Sheet 3 of 15 Sheets

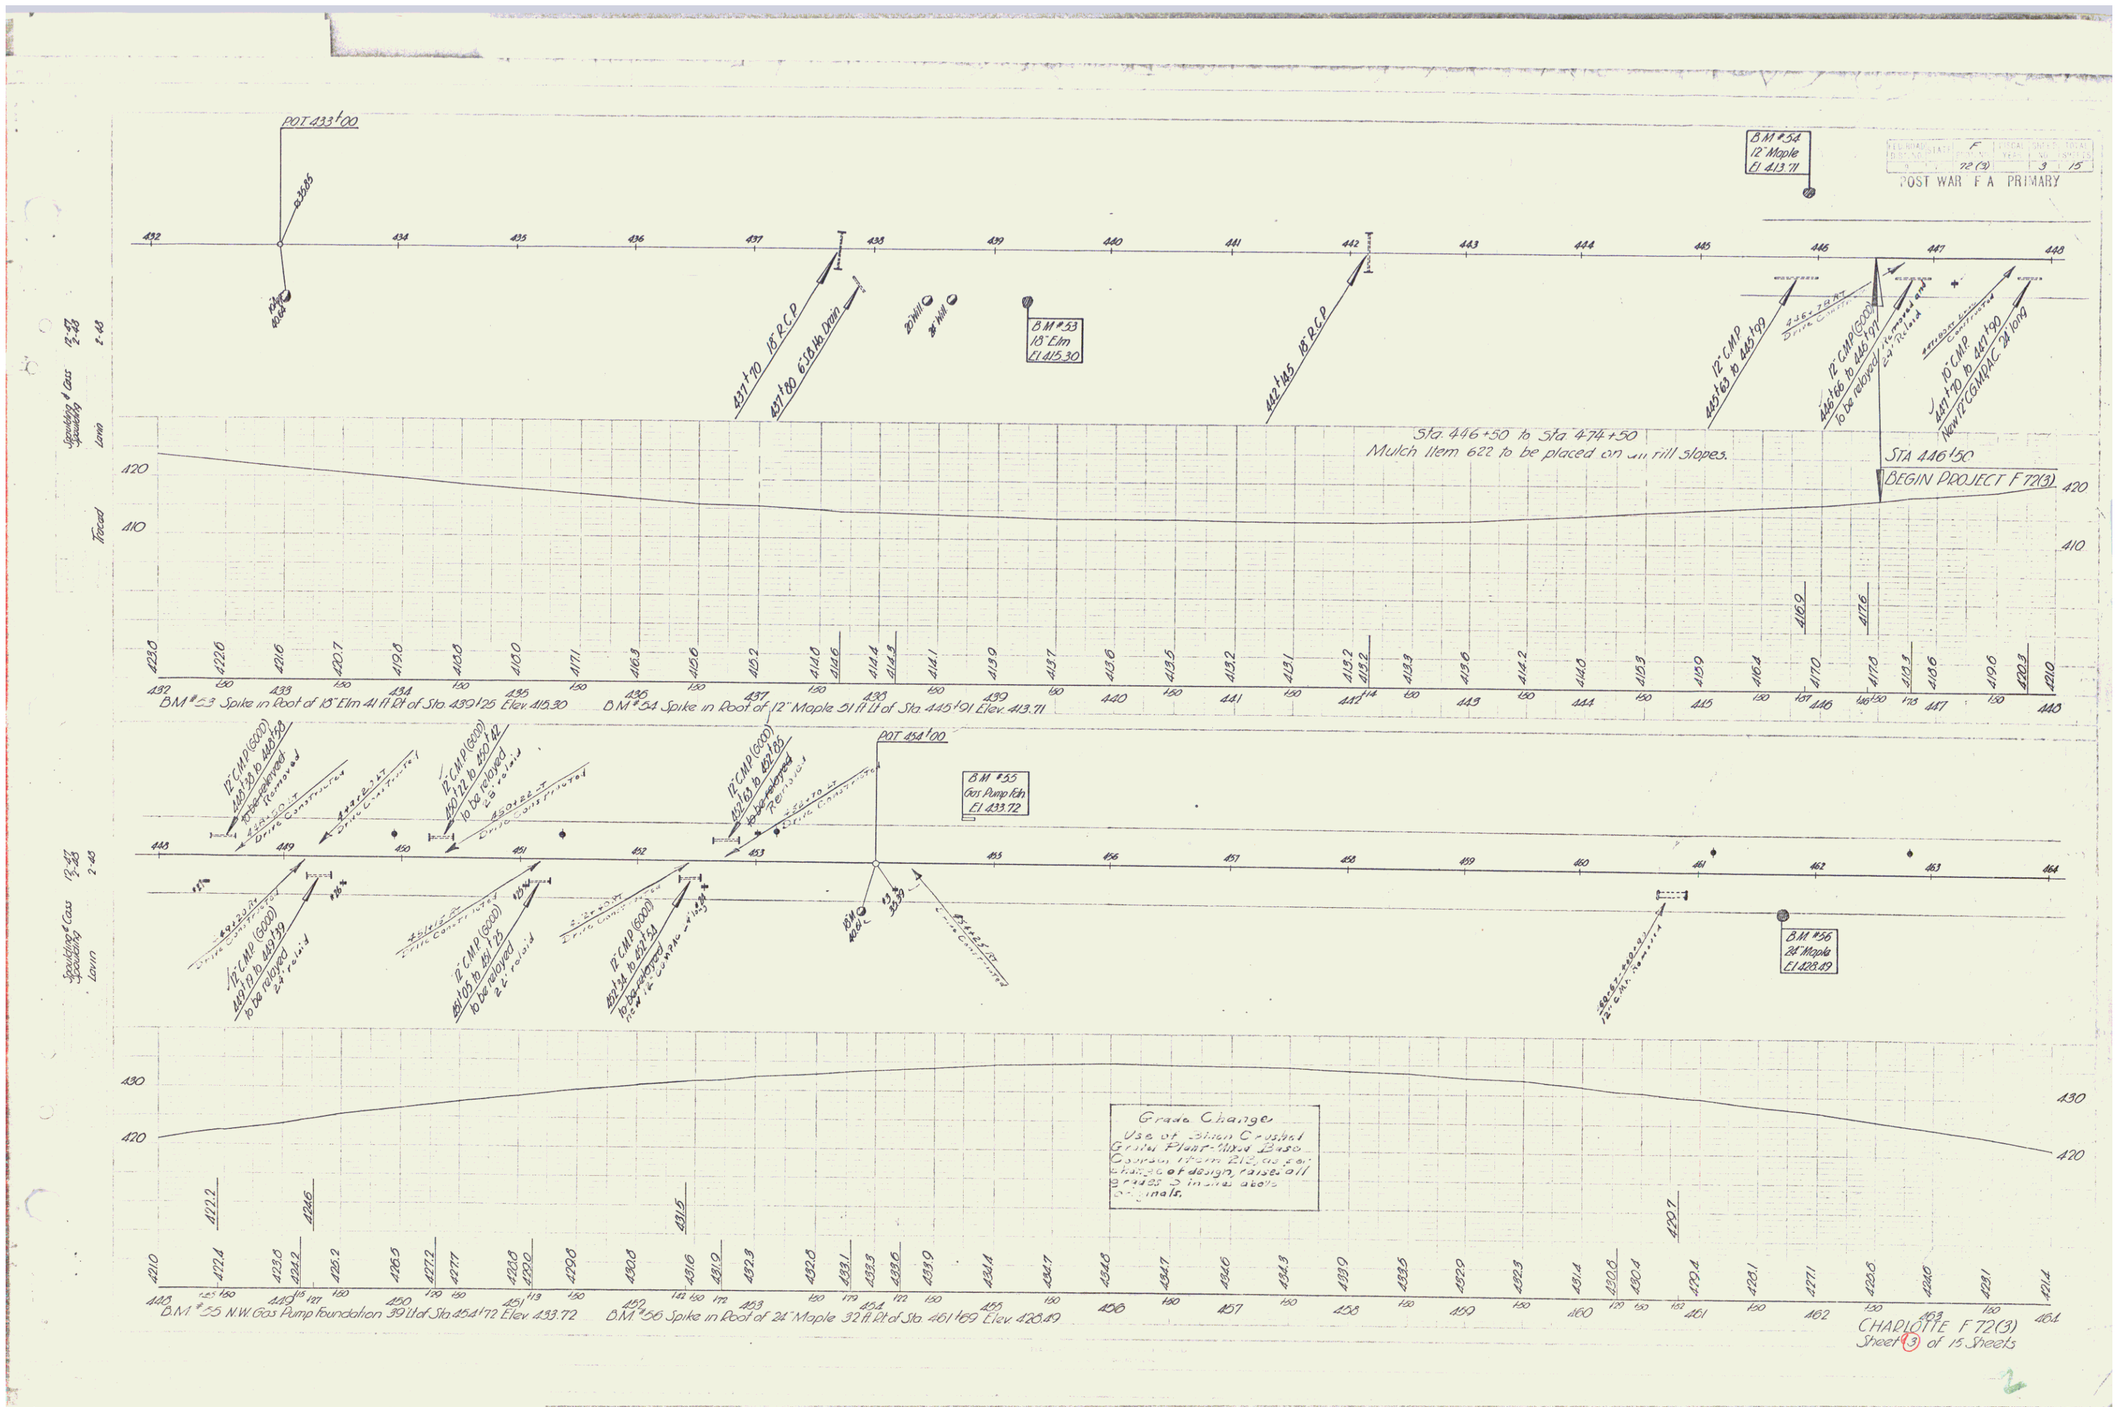
Course from 215 to 6.0 in.
Change of design raises all
grades 5 inches above
original.
BM #55 N.W. Gas Pump Foundation 39 Lt of Sta 454+72 Elev. 433.72
BM #56 Spike in Root of 24" Maple 32 ft Rt of Sta 461+69 Elev. 428.49
CHARLOTTE F 72(3)
